# PIC16F627A/628A/648A

## PIC16F627A/628A/648A Rev. A Silicon/Data Sheet Errata

The PIC16F627A/628A/648A parts you have received conform functionally to the Device Data Sheet (DS40044E), except for the anomalies described below.

FIGURE 1: BLOCK DIAGRAM OF RB1, RB2

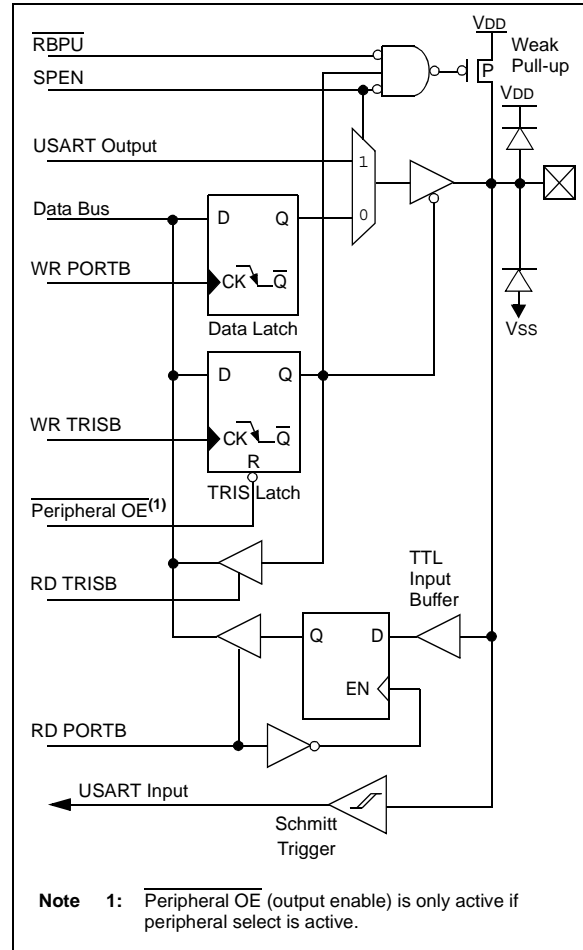
1. USART control of the RB1/RX/DT and RB2/TX/CK differs from the data sheet. Figure 5-9 and Figure 5-10 indicate that the USART circuit overrides the output drivers via the Peripheral OE signal. In fact, the Peripheral OE signal forces the TRISB<2:1> to an output (Reset) state (see Figure 1). Subsequently, the TRISB<2:1> must be set or configured to receive data.

In Asynchronous mode, when transmit is enabled (TXEN = 1 and SPEN = 1), the TRISB<2> latch is cleared to '0' by the USART peripheral circuitry. When disabling transmit (TXEN = 0), the TRISB<2> bit should be set to '1' to configure the RB2/TX/CK pin as an input.

In Synchronous mode, when changing from transmit to receive, clear the TXEN bit first, then set TRISB<1> to '1' to configure the RB1/RX/DT pin as an input before setting SREN or CREN to receive.

When disabling the USART (SPEN = 0), TRISB<2:1> should be reconfigured for input or output as required by the application.

**FIGURE 14-18: TYPICAL IN-CIRCUIT SERIAL PROGRAMMING™ CONNECTION**

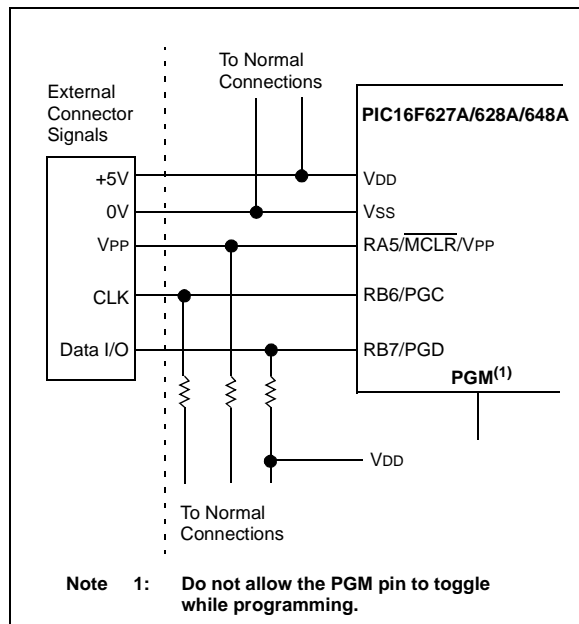
Section 14.11: In-Circuit Serial Programming and Figure 14-18: Typical In-Circuit Serial Programming Connection. The following paragraph and Note box are being added to the end of Section 14.11 and Figure 14-18 is updated to include PGM, noted in bold.

If LVP is not being used for programming, but the LVP Configuration bit is set (or LVP feature is enabled), the PGM pin must not be allowed to toggle while programming. The PGM pin is edge sensitive and if an edge is detected during programming, it may cause the PC to reset. If the LVP feature is disabled, the PGM pin will have no effect on programming.

**Note:** The LVP feature is enabled by default when the LVP Configuration bit is set.
